Application for Three Variances, Each Subject to Several Conditions, Respecting One Third Party Electronic Ground Sign - 3848-3998 Chesswood Drive

Date: September 20, 2021
To: Sign Variance Committee
From: Manager, Sign By-law Unit, Toronto Building
Wards: York Centre (Ward 06)

Figure 4 - Map of Districts within the Downsview Area Secondary Plan and The Proposed Sign:

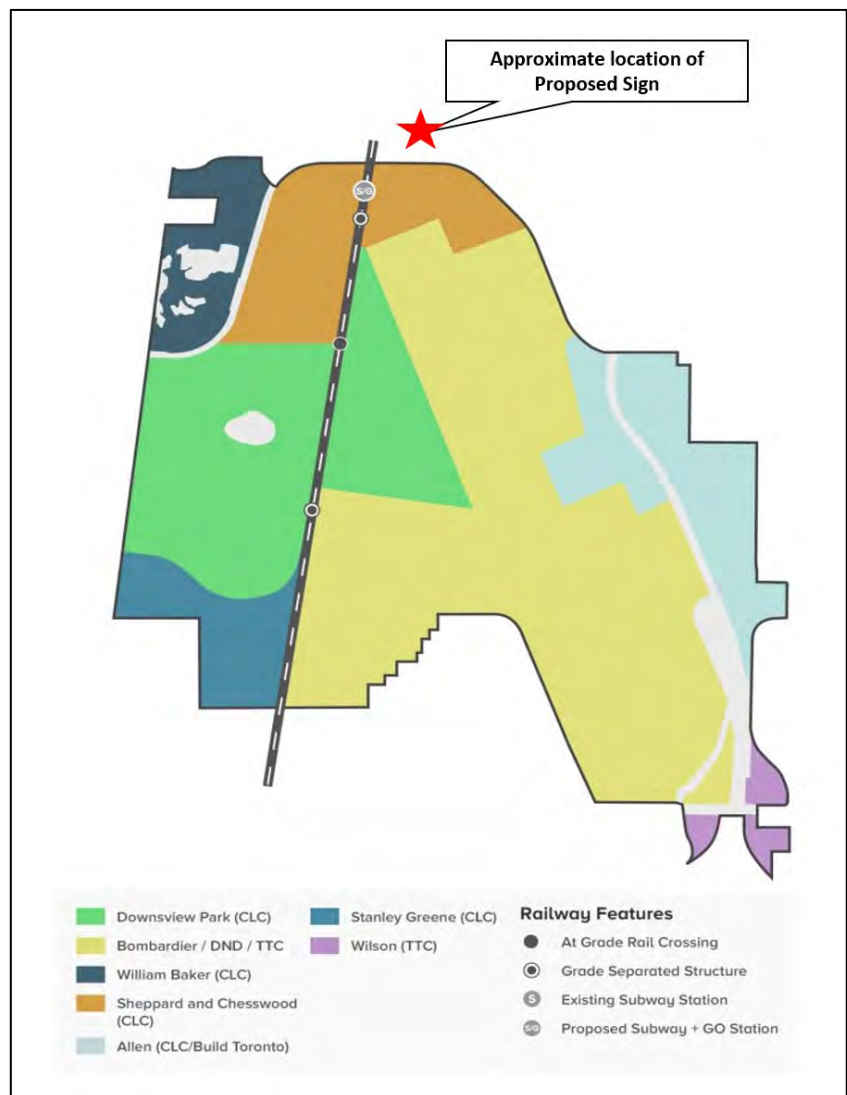
The City of Toronto's Downsview Area Secondary Plan further defines the area using seven smaller districts in order to focus future planning (See Figure 7).

The Sheppard district is at the north end of Downsview Park. The main feature of the Sheppard neighbourhood is the new TTC/GO station, at the north end of the district. This TTC/GO Station will be approximately 150m from the proposed sign.

A park space is permitted directly adjacent to the new TTC/GO Transit hub entrances and is intended to reinforce the importance of this site as a 'front-door' to the National Urban Park for transit users. If approved, the requested variances would have the condition that the Proposed Sign would not have a brightness exceeding 150 NITS between sunset and sunrise. The reduced brightness and distance of the Proposed Sign to the TTC/GO station and accompanying park space should limit or eliminate any impact that the Proposed Sign may have on the park space.

Figure 9 - Map 16 Land Use Plan - Toronto Official Plan Excerpt:

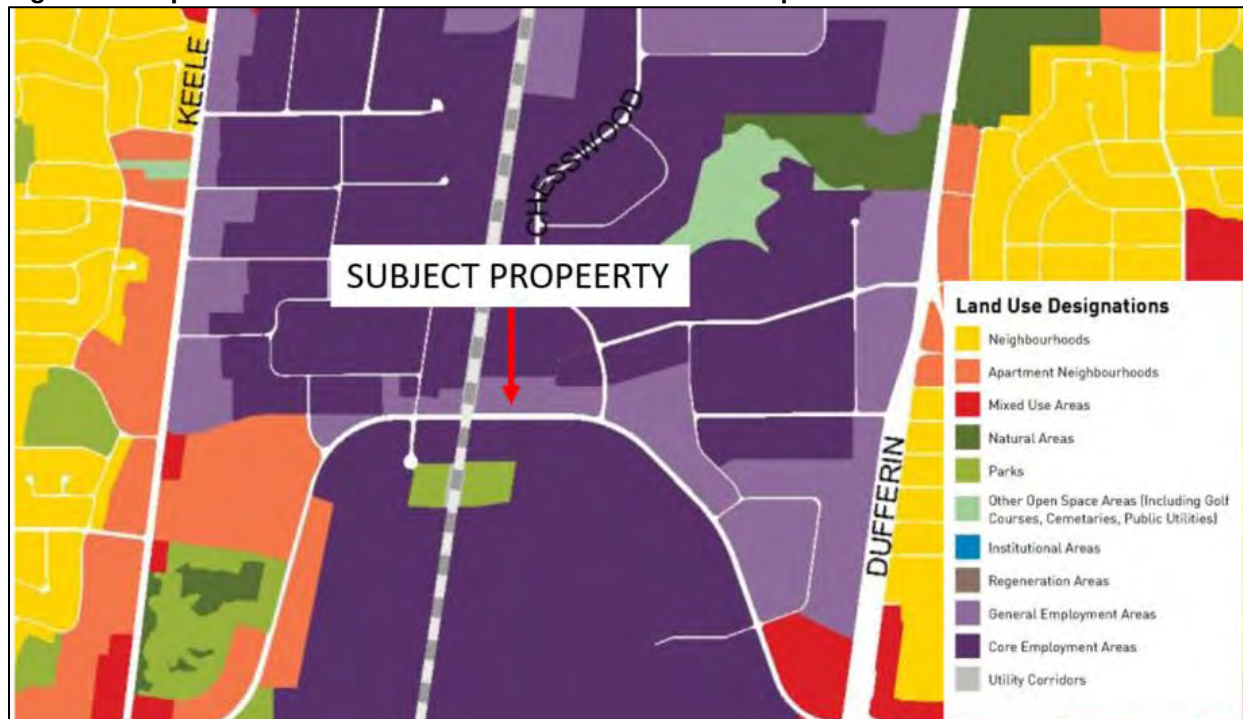
The area directly south of the Subject Premises is designated as Core Employment in the City of Toronto Official Plan (See Figure 9) which would permit primarily employment and industrial uses as well as smaller scale ancillary uses including retail shops and restaurants.

The property at 3848-3998 Chesswood Drive is designated as a General Employment Area within the Official Plan. Employment Areas are places of business and economic activity, and include a wide array of uses such as manufacturing, warehousing, distribution, research and development facilities, utilities, media facilities, parks, hotels, retail outlets, restaurants and small-scale stores and services that serve these businesses and workers.

Staff agree that these points raised by the applicant also support Policy Statement 2.2.4 2 b) c) and j) in Chapter 2 of the Official Plan which states that:

Figure 10 - Clearance Height of the Proposed Sign:

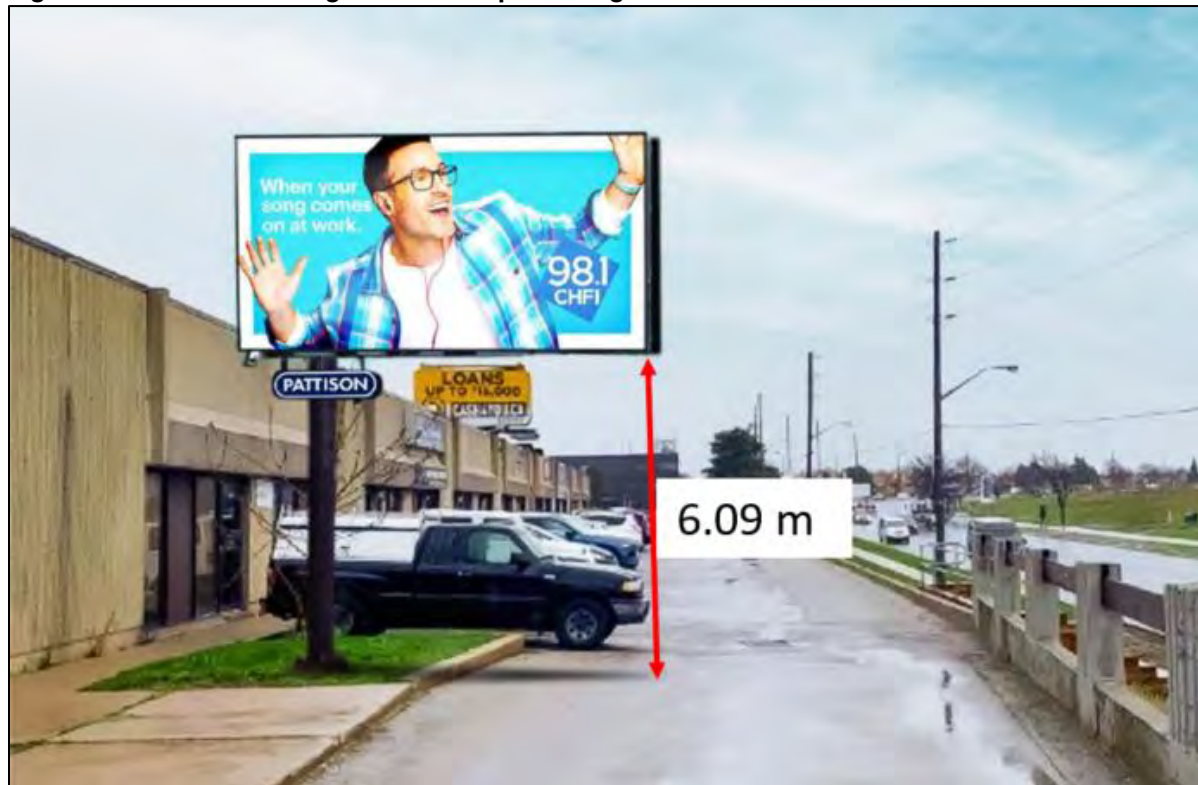
The support pole for the Proposed Sign would be located in a landscaped area which has concrete curb around the perimeter (See Figure 4) and would not obstruct any pedestrian pathways. Additionally, the portion of the Proposed Sign that would overhang the vehicular travelled portion of the private lane and would have a clearance height of more than 6.0 metres from grade to the bottom of Proposed Sign (See Figure 10), due to the condition respecting the minimum height of the sign face bottom. The clearance height exceeds the minimum of 4.25 metres which is a requirement in Ontario

Building Code and ensure that vehicles can pass safely underneath the Proposed Sign without obstruction.
